Tree Farm- East Toolhouse

Accessibility Review

City of Duluth, MN

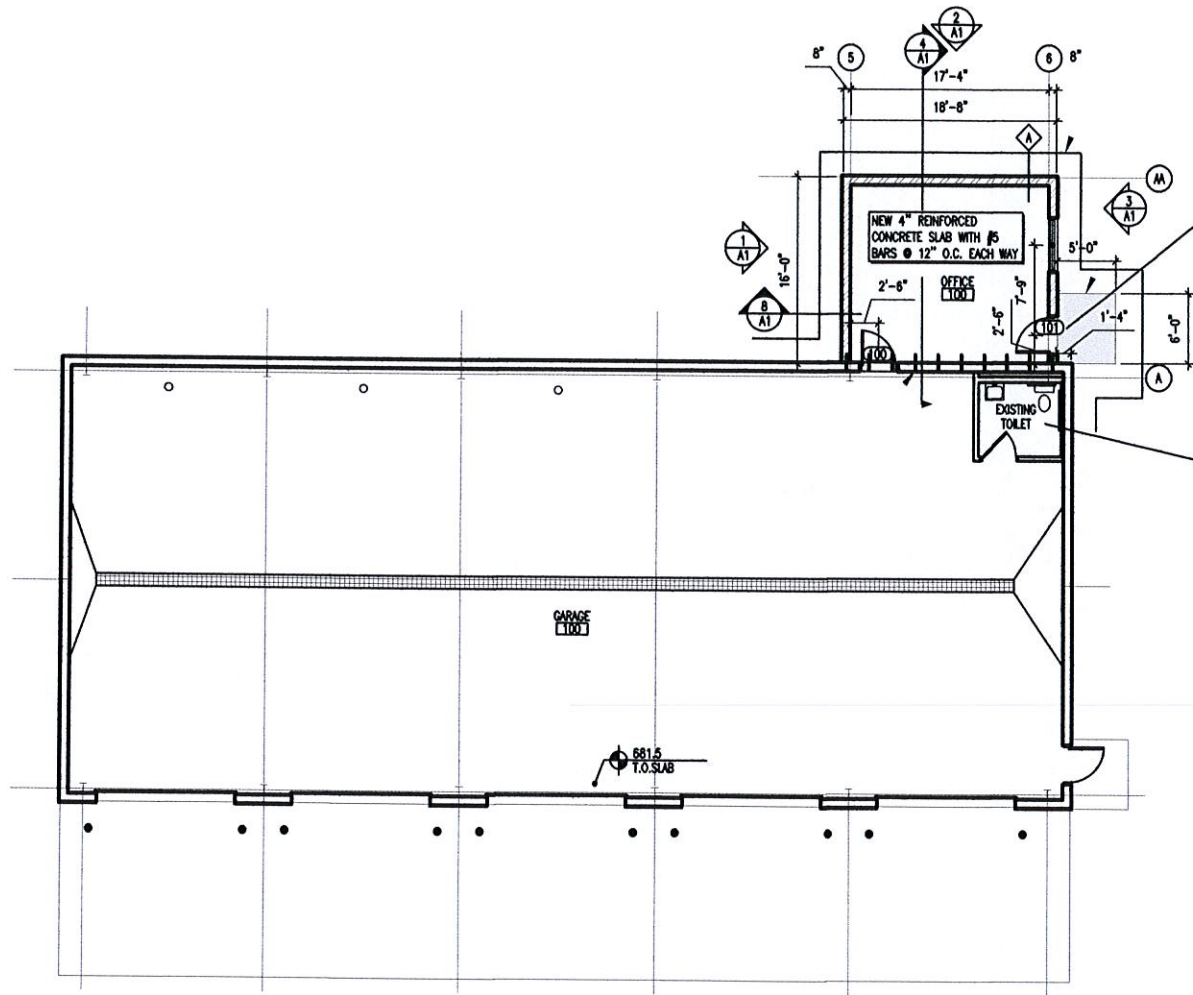
[L] Install door lever hardware
